4th Stakeholder Advisory Forum West Texas Igneous and Bolson GAM

November 20, 2003

QUESTIONS AND ANSWERS
West Texas Igneous and Bolson GAM
SAF Meeting 4 – November 20, 2003
Van Horn, Texas

Layer 2 Boundary Conditions

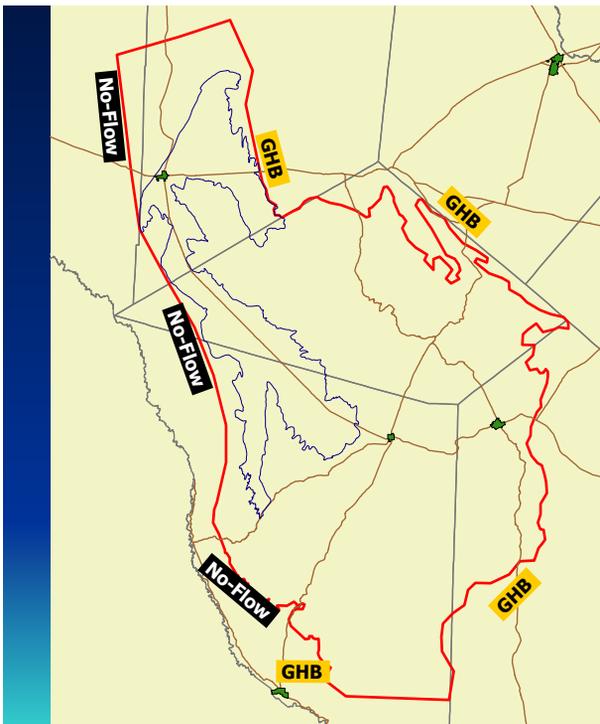
Q: Why have you set no-flow boundaries in layer 2 in areas where flow is known to occur?

A: The thickness of the igneous aquifer generally decreases near the boundaries. Many of the grid blocks “dry out” and become inactive for the steady-state and transient simulations, which causes the general head boundaries at the edges of the model to become inactive in those areas also. To ensure that flow can continue to move out of the model (as is indicated by measured water levels), general head boundaries have also been incorporated in layer 3 to ensure that water can actually move out through layer 3 if layer 2 dries out.

Initial Distribution Of Recharge

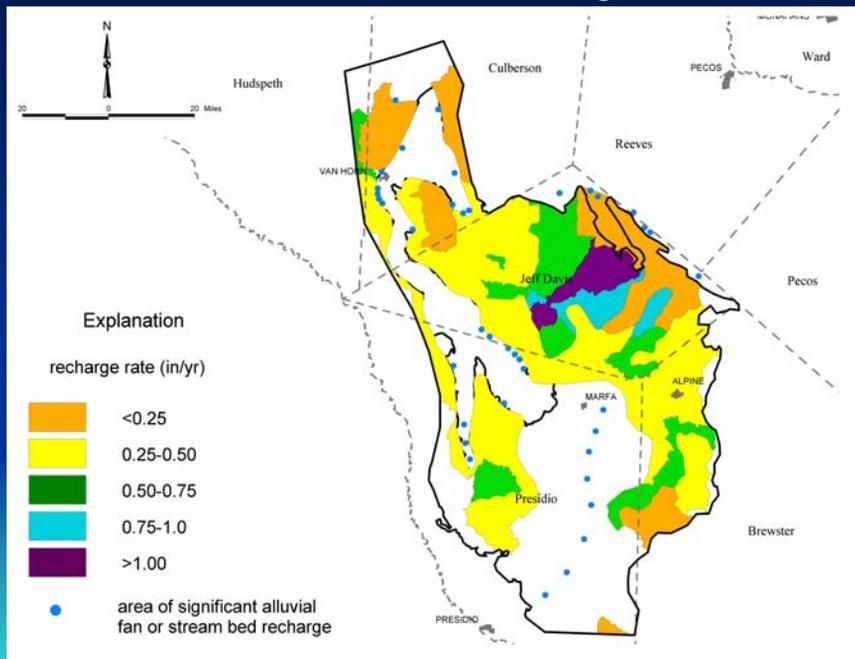
Q: How has recharge been modified since its initial input?

A: Sensitivity analysis is being performed on recharge. For the steady-state calibration, it appears that approximately 60% of original recharge estimate (that shown in the draft conceptual model report) is reasonable. This is consistent with the findings of other groundwater modeling studies that have been performed in the southwest U.S. that have incorporated this method of recharge estimation. The value may be further modified further during the transient calibration.
